SERVICE BULLETIN NO. MSB1078-163/1

1.4 Subject:

ATA-Code: 20-10 Standard Practices - Airframe
 57-10 Wing Structure

G 115C/D/E/EG

Fig. 3

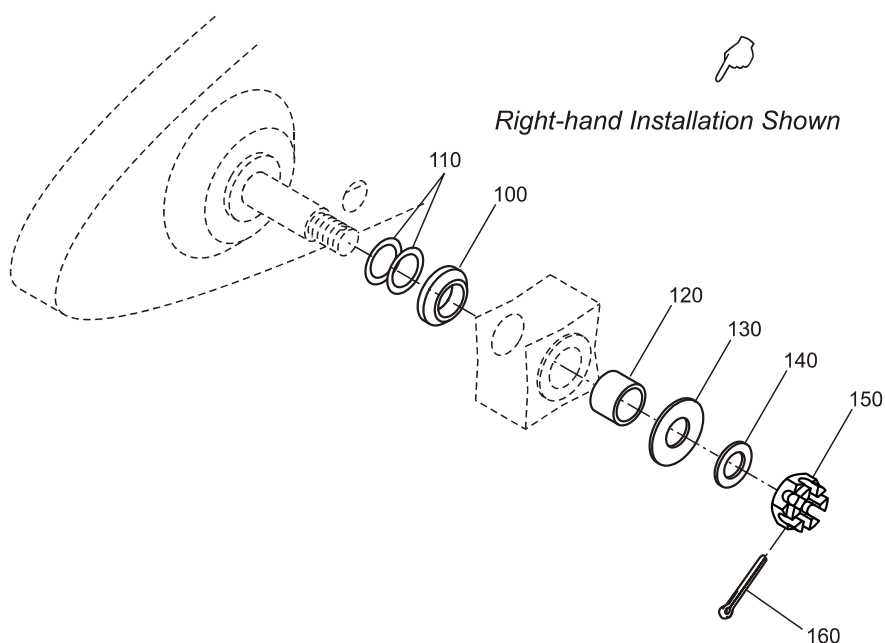
- 1.8.4. Remove cotter pin LN94-4x30 (Fig. 3, item 160) from each wing shear bolt.
- 1.8.5. Release castellated nut P/N LN9345-M16x1,5 (Fig. 3, item 150) as follows:

- turn open both nuts at the LH a half turn
- if washers underneath are turnable, the shimming between wing and fuselage is correct and you may proceed with para. 1.8.6
- if washers underneath is not turnable, proceed as follows:
 - release castellated nuts further stepwise by 1/3 turns until washer is turnable. Note number of 1/3 turns to determine required additional shims (1 whole turn = 1.5mm, thread pitch)
 - remove LH wing I.A.W. MM chapter 57-10
 - install additional shims P/N 115C-1001.28 (Fig. 3, item 110, thickness 0.5mm) between wing and fuselage as required
 - install wing I.A.W. MM chapter 57-10, torque each castellated nut with 20 - 50 Nm (14.75 – 36.87 lbf.ft), note para. 1.9

1.8.8. Install cotter pin LN94-4x30 to each wing shear bolt. If the cotter pin can not be installed within the torque range specified in 1.8.7 use shims P/N DIN 988- 24x17x thickness as required to be placed between the two washers (item 130 and 140).

1.8.7. Torque each castellated nut with 20 - 50 Nm (14.75 – 36.87 lbf.ft).
